TDI DIESEL GENERATOR

**DESIGN REVIEW
AND
QUALITY REVALIDATION
REPORT**

TENNESSEE VALLEY AUTHORITY

BELLEFONTE NUCLEAR PLANT

FIGURE 1
EXHAUST MANIFOLD PIPING

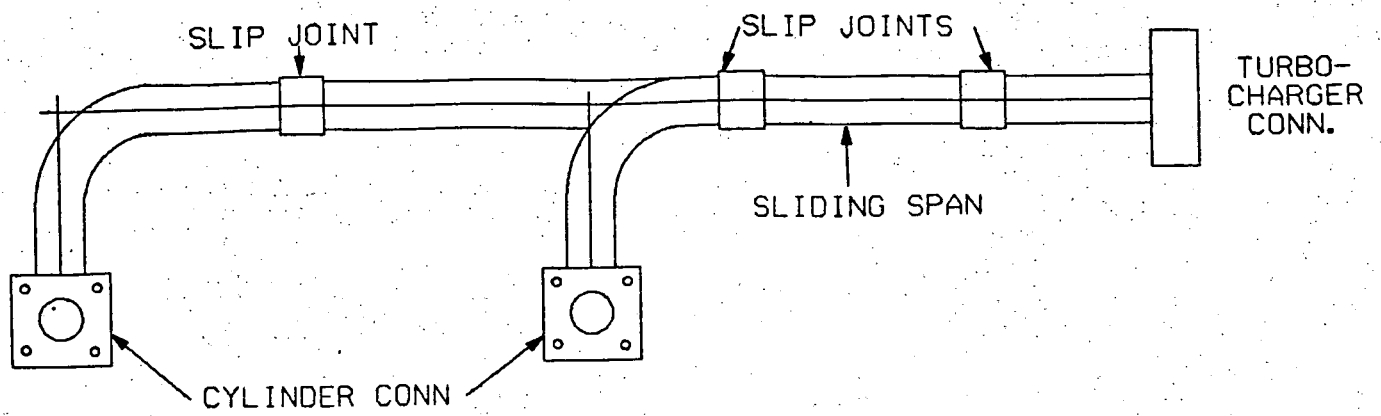
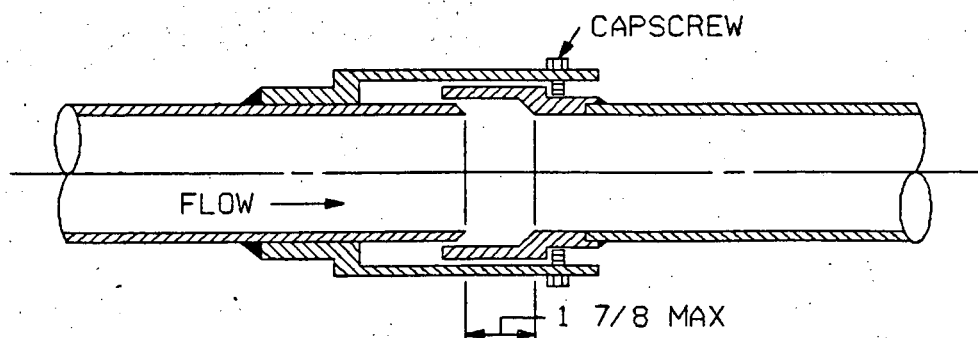
It is expected that friction from the seals in the slip joints will provide sufficient force (approximately 142 lb.) to move the sliding span along with the adjoining pipe during a seismic event while allowing relative thermal movements. The seismic displacements and rotations at the slip joint are negligible (displacements approximately .1 inches, rotations approximately .015 radians). Even if the friction force is inadequate to keep the sliding span moving with the adjoining pipe sections, restraining devices are provided to prevent separation of exhaust piping. The gap associated with the slip joint at both normal operating and ambient temperatures is much larger than the total relative movements of the adjacent piping. Therefore, no significant impact between the sliding span and adjacent piping will occur.

Based on this evaluation (Reference No. 2), the exhaust manifold piping has been found to be acceptable without modification. All stress levels remain well below code allowables (maximum stress ratio of approximately 0.4). Nozzle loads are not significantly increased from those approved in the original calculation. Relative movements at the slip joints are very small and the restraining devices are adequate to prevent any lock up or separation of the exhaust piping.

The exhaust manifold piping as designed and installed by Transamerica Delaval, Inc. is adequate to perform its intended design function.

FIGURE 1
EXHAUST MANIFOLD PIPING

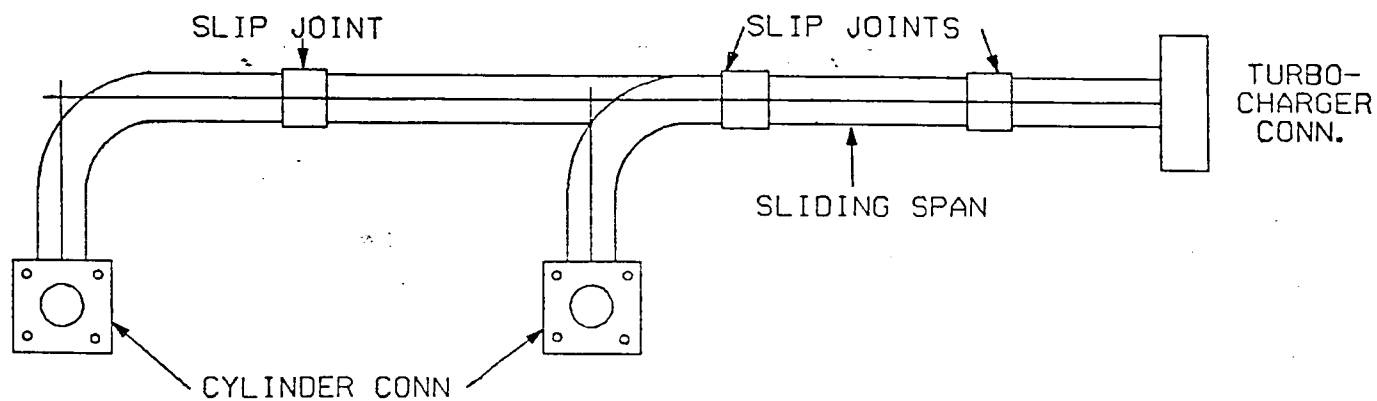
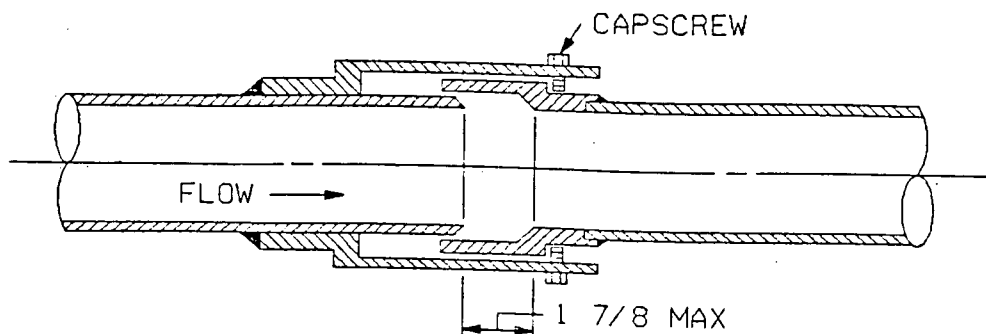
It is expected that friction from the seals in the slip joints will provide sufficient force (approximately 142 lb.) to move the sliding span along with the adjoining pipe during a seismic event while allowing relative thermal movements. The seismic displacements and rotations at the slip joint are negligible (displacements approximately .1 inches, rotations approximately .015 radians). Even if the friction force is inadequate to keep the sliding span moving with the adjoining pipe sections, restraining devices are provided to prevent separation of exhaust piping. The gap associated with the slip joint at both normal operating and ambient temperatures is much larger than the total relative movements of the adjacent piping. Therefore, no significant impact between the sliding span and adjacent piping will occur.

Based on this evaluation (Reference No. 2), the exhaust manifold piping has been found to be acceptable without modification. All stress levels remain well below code allowables (maximum stress ratio of approximately 0.4). Nozzle loads are not significantly increased from those approved in the original calculation. Relative movements at the slip joints are very small and the restraining devices are adequate to prevent any lock up or separation of the exhaust piping.

The exhaust manifold piping as designed and installed by Transamerica Delaval, Inc. is adequate to perform its intended design function.
